Survey of members of Visions for Armidale Creeklands (November 2021)

Ranking of Agreement with 20 items listed in adopted Work Plan (see Appendix) for Stage1 of Creeklands Master Plan

Text comments received from members in November 2021 survey about plans for Stage 1 of Creeklands Master Plan

Ranking of Stage 1 plan items - Visions for Armidale Creeklands members - Nov 2021

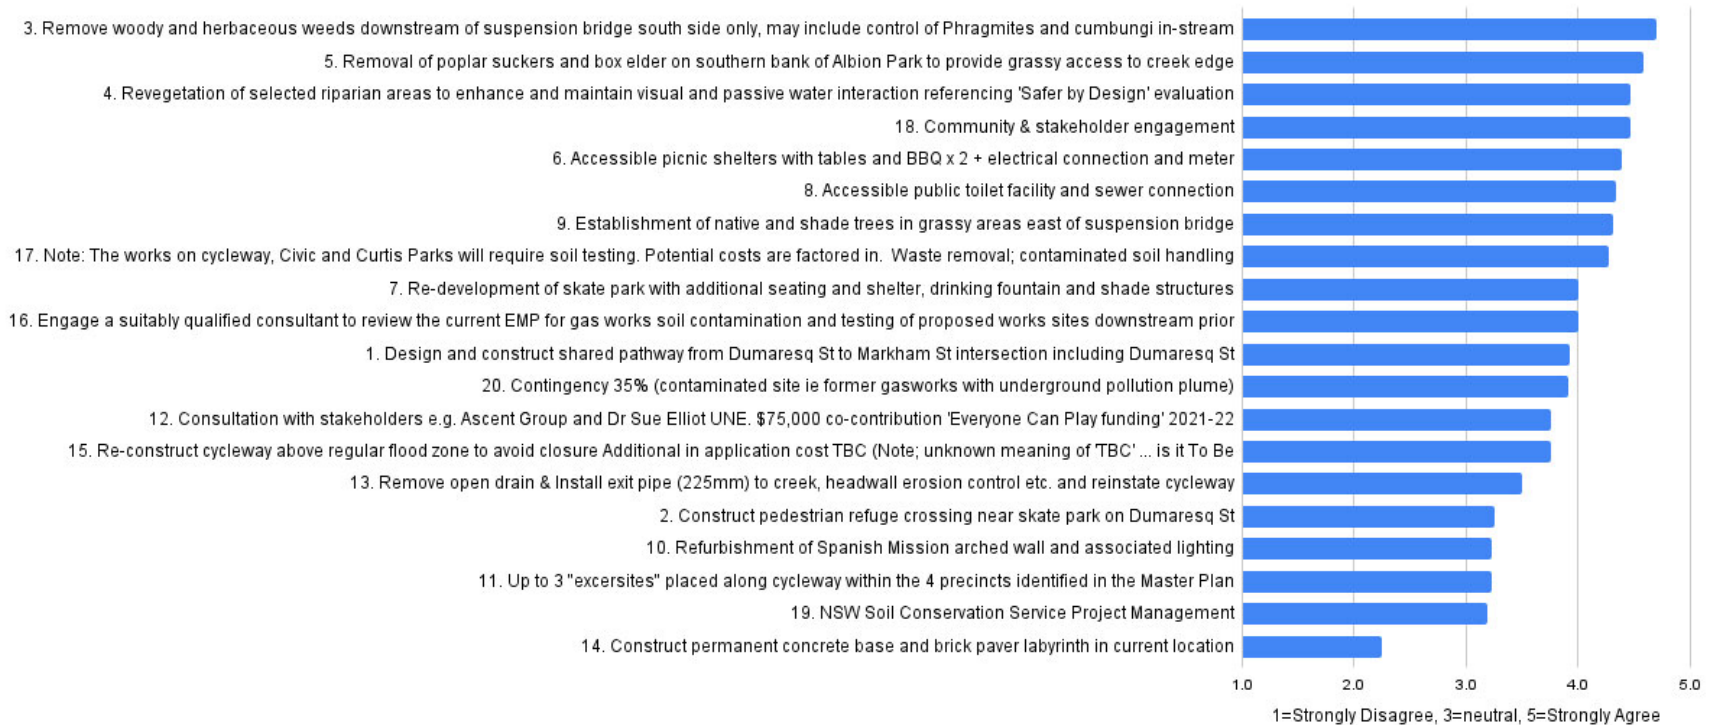
- Highest ranked items relate to vegetation changes.
- Lowest ranked item is for labyrinth.
